Amended Plans Submission Form (Application Not Approved)

Property: 33 Nancarrow Ave Ryde

LDA No: LDA2015/0032 CC No: —
(If amended plans for DA) (If amended plans for CC)
(include prefix – eg LDA2009/0001) (include prefix – eg PCA2009/1234)

[RE: DEVELOPMENT APPLICATION REF:LDA 2015/0032, SHEPHERDS BAY STAGES 6 AND 7, ADDRESS: 37-53 NANCARROW AVENUE, RYDE](#)

Stage 6: Section illustration of proposed basement levels and implication of basements only below footprint.

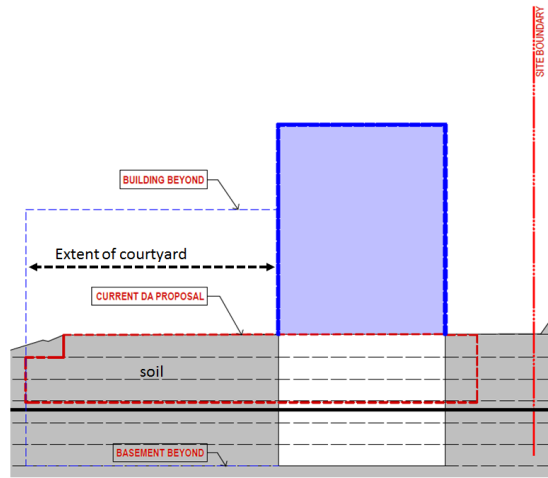
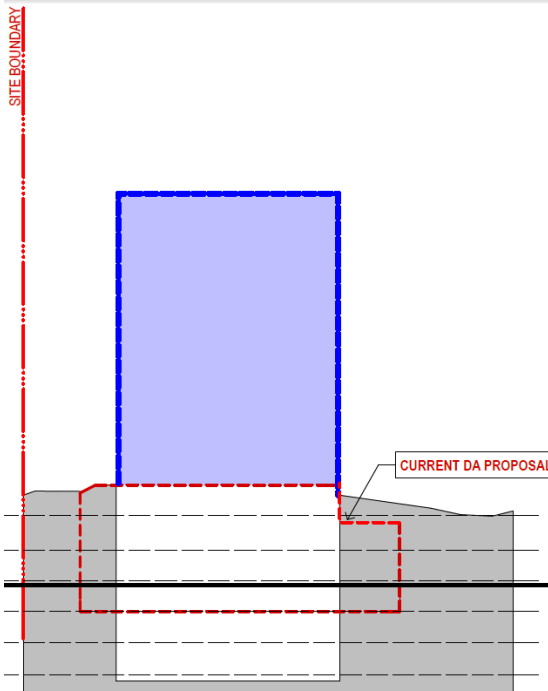
<p>With reference to the modification of Minister's Concept Approval dated 16 October 2014, the following issues are required to be addressed:</p>	
<p>a) Scaled and dimensioned drawings</p> <p>In order to accurately assess the built form of the proposed development and accompanying SEPP 65 report relative to the modified concept approval, amended plans, sections and elevations drawn to scale and fully dimensioned including boundary setbacks and floor to ceiling heights(already provided) and floor to floor heights are required to be submitted. It is noted that RLs have been annotated in the proposed plans, sections and elevations; however dimensioned details are still required in this instance.</p>	<p>We are unsure as to what this request refers to. As per Council's DA Checklist, Scaled plans were submitted with the DA.</p>
<p>b) Basement footprints</p> <p>Condition No.4 of the modified concept approval requires:</p> <p>"Future Development Applications shall ensure that basement parking levels do not exceed 1 metre above ground level (finished) and are located below the building footprint (with the exception of basements connecting Stages 2 and 3 and Stages 4 and 5) without encroachment into street setback areas."</p> <p>Concerns are raised that the proposed basement areas extend beyond the building footprint</p>	<p>Due to the narrow footprints of the two proposed buildings in Stages 6 and 7, an interpretation of Concept Plan consent Condition No. 4 to require basements only under the buildings above would result in extremely inefficient basement layouts with the inevitable result being the need to increase from 3 to 6 basement levels and additional excavation and dewatering and general disturbance of the site. The basement design for Stage 7 would be especially poor because the ramping would occupy the majority of each basement level, and this could only be alleviated with the use of car lifts, which is also a poor and unnecessary outcome.</p>

underneath the communal garden area of Stage 6 and within the street setback areas of Stage 7. As such detailed justification for the non-compliance including consideration of providing additional basement levels underneath the building footprint is required to be submitted.

Sketch plans are provided below which illustrate the ramifications of this approach.

The core objective for locating basements only under building footprints is to ensure that sufficient deep soil is provided on site, which was central to the Planning Assessment Commission’s consideration of the issue for Stages 2, 3, 4 and 5.

In this instance, the proposed basement arrangement still results in 52.86% of the open space and 25.8% of the site as being deep soil. This is profoundly in excess of the minimum requirements of the Residential Flat Design Code which requires 25% of the open space to be provided as deep soil and 6.25% of the site to be provided as deep soil (based on minimum common open space area of 25% of site). It is also well in excess of the 7% deep soil required under the new Apartment Design Guide which will replace the Residential Flat Design Code.

Stage 7: Illustration of the required extent of ramping for a basement level contained only under the building footprint which occupies the majority of each basement level

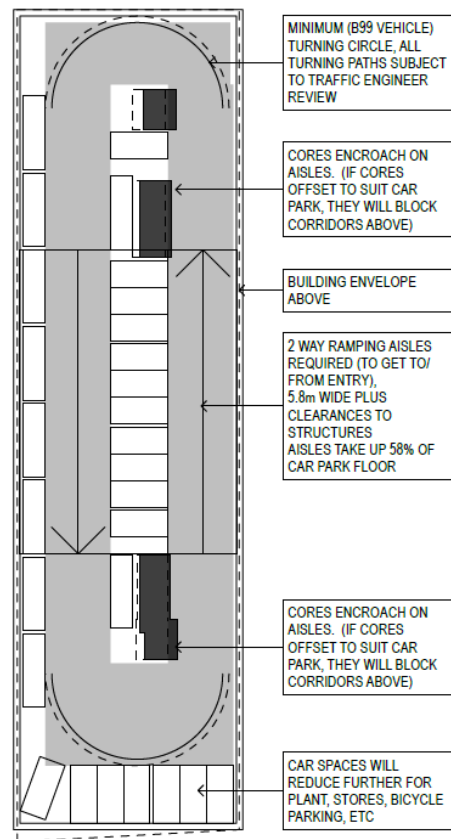
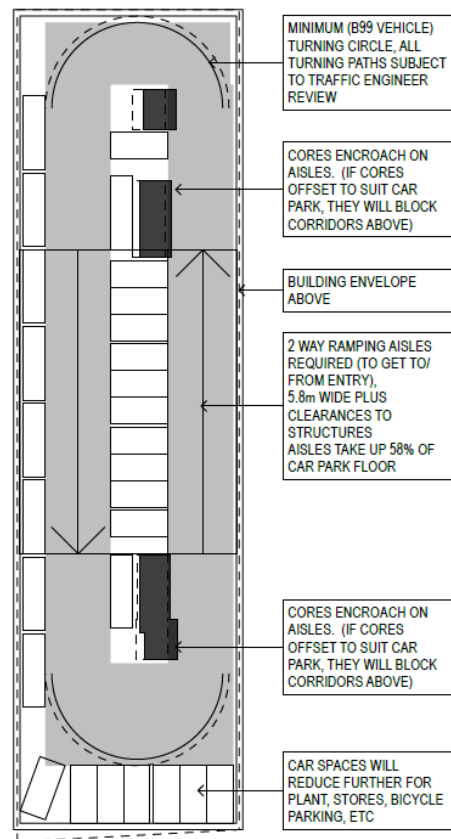
Council Issue

Sketch Plan L4
 Stage 7A
 1:100 @ A3
 17.06.15

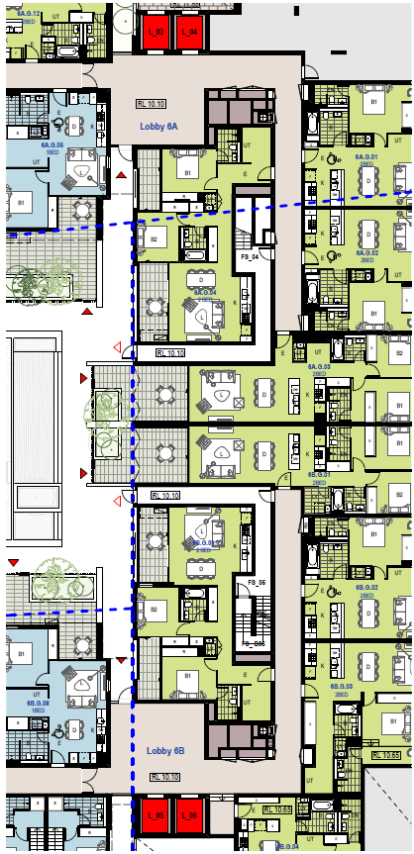
<p><i>Basement carparking</i></p> <p><i>The proposal includes a three and four level basement. Due to the sloping site, the basement potentially protrudes above ground level along the central stormwater easement, although some apartments 'sleeve' the basement along this alignment (above a basement podium). At some points however, the potential extent of the basement protrusion above ground level (approximately 1.2m) may create undesirable impacts to the quality of the primary site link and should be carefully mitigated.</i></p>	<p>Condition No. 4 of the Concept Plan states that Future Development Applications shall ensure that basement parking levels do not exceed 1 metre above finished ground level. The proposed development conforms to this requirement and the proposed earthworks will achieve a positive outcome for the area because they will achieve basement levels with minimal protrusion to a maximum of 1 metres above finished ground level which will serve to reduce the apparent mass and scale of the development and provide an improved relationship</p>

Council Issue	Response
	<p>between the buildings and surrounding public domain. As the basement protrusion is limited to a maximum of only 1 metre above finished ground level and with a landscaped treatment around the perimeter of the basements, the basements will not result in an adverse impact to the quality of the primary through site link.</p>
<p>Building separation</p> <p><i>At points along the primary site link, it appears that the basement protrudes above natural ground relative to Stage 6. This situation is not acceptable and warrants mitigation primarily through the landscape design response</i></p>	<p>The maximum protrusion of the basement level for Stage 6 above the finished ground level is 1m which is a conventional and acceptable outcome.</p>
<p>Privacy and building configuration</p> <p><i>Generally, the configuration and internal planning of the buildings is clear and strong. Natural light and ventilation is apparent in many common circulation spaces. The Panel encourages a similar approach to internal corridors in Stage 7.</i></p>	<p>Turner Architects have reviewed Stage 7 to investigate locations where additional natural light can be provided to the internal corridors via external window or skylight, or borrowed natural light. Natural light has been increased as follows:</p> <p>Stage 7A</p> <ul style="list-style-type: none"> • GL (entry level) • L1 (new window to double height lobby) • L4 (new skylights over) <p>Stage 7B</p> <ul style="list-style-type: none"> • LG (entry level) • GL (new window to double height lobby) • L5 (glazed at NW end) • L6 (glazed at SE end)  <p style="text-align: right;">Sketch Plan L1 Stage 7A 1:100 @ a3 17.06.15</p>

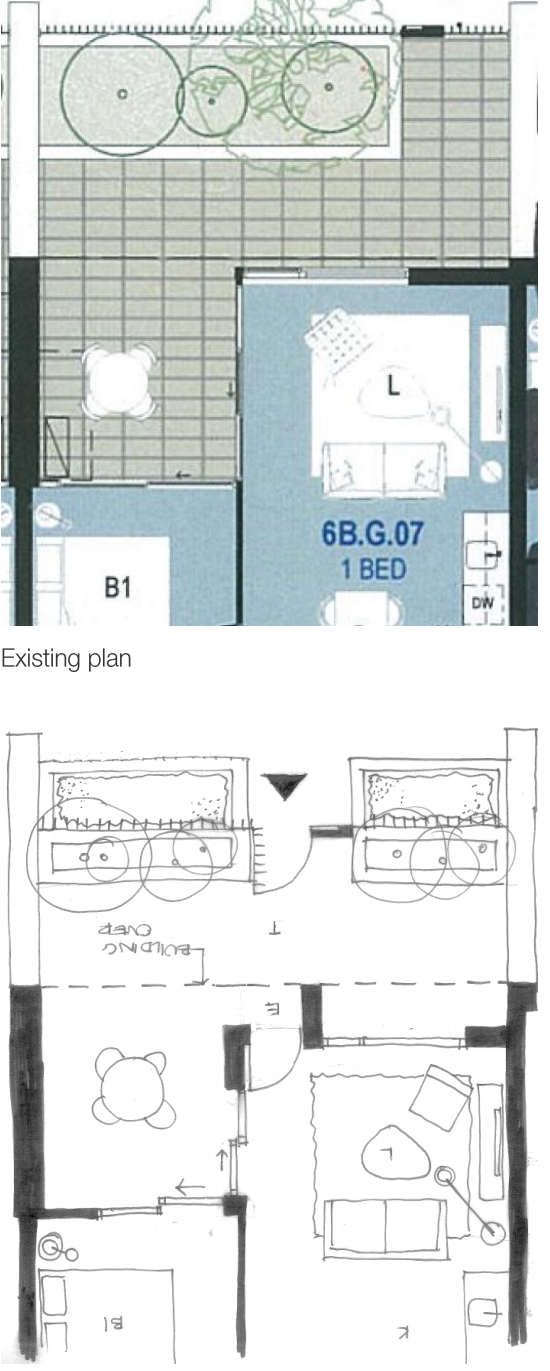
Council Issue	Response
<p><i>appears, generally, to be acceptable, mitigating privacy and managing cross viewing.</i></p> <p><i>The Panel is concerned, however, with this configuration at ground level where communal open space connects to Lobby 6A and 6B. Here, residents using the communal open space are brought into close proximity with habitable rooms through a relatively constrained common corridor. Bedroom balconies (unit 6A.G.04 and 6B.G.09) and living room windows (units 6A.G.05 and 6B.G.08) appear to open directly onto these common circulation spaces without any mitigation of visual or acoustic privacy conflicts that will occur.</i></p>	<p>associated reconfiguration of apartments to reduce the proximity of habitable rooms to common circulation spaces.</p> <p>This is illustrated in the images below of the originally proposed ground floor arrangement and the amended arrangement. Of Units 6A.G.04, 6A.G.03, 6B.G.01 and 6B.G.09.</p>  <p>Originally proposed ground floor of Stage 6</p>

Council Issue	Response
	 <p>Existing plan</p> <p>Proposed plan</p>
<p>Solar access</p> <p><i>The proposal needs to demonstrate the extent of any self-shadowing impacts. It would appear that elements of Stage 6B, particularly at lower levels, will be compromised by overshadowing. Although consistent with the Concept Plan envelope approval, this self-shadowing should be, in part, offset by the provisions of Condition 21 'enhanced amenity'.</i></p>	<p>The solar access analysis undertaken by Turner Architects and submitted with the development application did take into account self shadowing, as evidenced by the fact that the lower apartments in the southern 'wing of Stage 6 are marked as not receiving solar access whilst apartments on the same alignment higher in the building do benefit from solar access. Elevation solar access diagrams will be provided with the amended architectural package to</p>
